Project	IEEE 802.16 Broadband Wireless Access Working Group < http://ieee802.org/16 >	
Title	Action Items from Session #45	
Date Submitted	2006-11-14	
Source(s)	Paul Piggin NextWave Broadband Inc. 12670 High Bluff Drive San Diego CA 92130 USA	Voice: 1 858 480 3100 Fax: 1 858 480 3105 ppiggin @ nextwave.com
Re:	Working Group Letter Ballot #24 for IEEE P802.16h/D1.	
Abstract	This document contains a resolution of action items assigned during Session #45.	
Purpose		
Notice	This document has been prepared to assist IEEE 802.16. It is offered as a basis for discussion and is not binding on the contributing individual(s) or organization(s). The material in this document is subject to change in form and content after further study. The contributor(s) reserve(s) the right to add, amend or withdraw material contained herein.	
Release	The contributor grants a free, irrevocable license to the IEEE to incorporate material contained in this contribution, and any modifications thereof, in the creation of an IEEE Standards publication; to copyright in the IEEE's name any IEEE Standards publication even though it may include portions of this contribution; and at the IEEE's sole discretion to permi

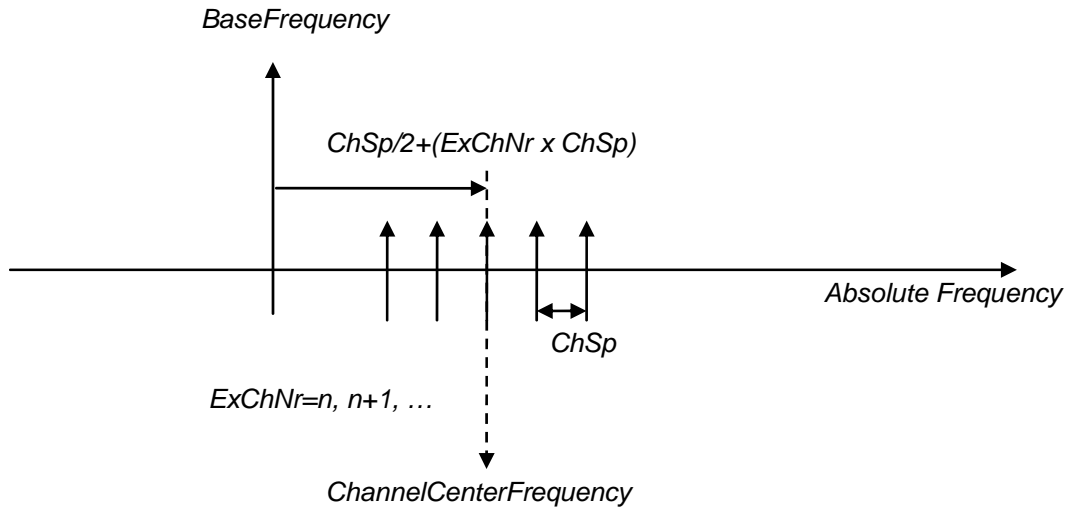
An illustrative example for 3.65-3.7GHz band with 5MHz channelisation is given:

Replace figure h1 with the following:

$$\text{BaseFrequency (kHz)} = 3\ 650\ 000$$

$$\text{ChSp (10kHz)} = 5\ 00$$

$ExChNr = 0, 1, 2, 3, 4, 5, 6, 7, 8, 9$

$ChannelCentreFrequency$ (MHz) = 3652.5, 3657.5, 3662.5, 3667.5, 3672.5, 3677.5, 3682.5, 3687.5, 3692.5, 3697.5
